# Access Compliance Report

## Public Rights-of-Way

Intersection ID: 20280	Main Street: CEDAR_HILL_DR	Cross Street: LARIX_DR	Location: SE
ADA ID: BCC2227C47EC	Ramp Type: PerpDiag	Initial Pass/Fail: Fail	Overall Compliance: No
			Severity Score: 26.25

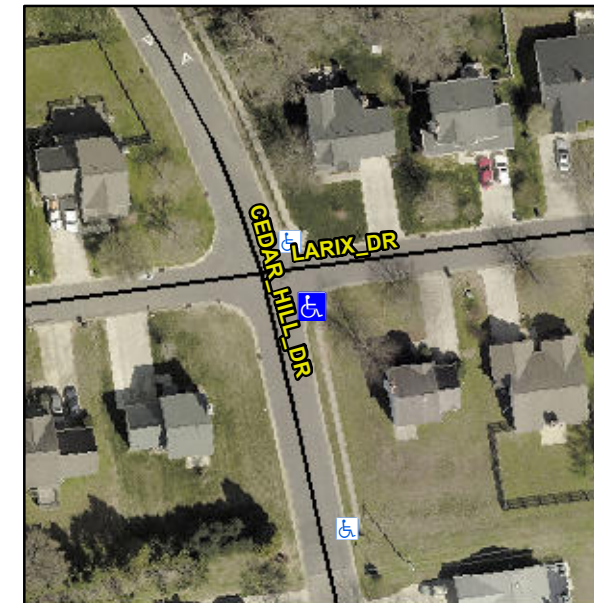
**Not Found, R304.2.2, R304.5.3**

Compliance	Description	Data	Compliance	Description	Data
N/A	Ramp Length (in)	50.0	No	Ramp Slope (%)	13.0
Yes	Ramp Width (in)	52.0	No	Ramp XSlope (%)	4.3
N/A	Flare Type LT	N/A	N/A	Flare Type RT	N/A
N/A	Flare Slope LT (%)	N/A	N/A	Flare Slope RT (%)	N/A
N/A	Flare Traversable LT?	N/A	N/A	Flare Traversable RT?	N/A
N/A	Landing Length (in)	N/A	N/A	DWS Provided?	N/A
N/A	Landing Width (in)	N/A	N/A	DWS Contrast?	N/A
N/A	Landing Slope (%)	N/A	N/A	DWS Length (in)	N/A
N/A	Landing X Slope (%)	N/A	N/A	DWS Full Width?	N/A
N/A	Landing Curb? (Y/N)	N/A	N/A	DWS Offset (in)	N/A
N/A	Shared Landing?	N/A			
N/A	Gutter Ponding?	N/A	N/A	Gutter Slope (%)	N/A
N/A	Gutter Lip Ht (in)	N/A	N/A	Gutter X Slope (%)	N/A
N/A	Painted X Walk1?	No	N/A	Painted X Walk2?	No
	X Walk 1 Direction	To N		X Walk 2 Direction	To W
N/A	X Walk 1 Width (in)	N/A	N/A	X Walk 2 Width (in)	N/A
	X Walk 1 Slope (%)	0.3		X Walk 2 Slope (%)	5.7
	X Walk 1 X Slope (%)	3.7		X Walk 2 X Slope (%)	1.5

**Remove & Replace Curb Ramp With Two New Directional Ramps or Equivalent.**
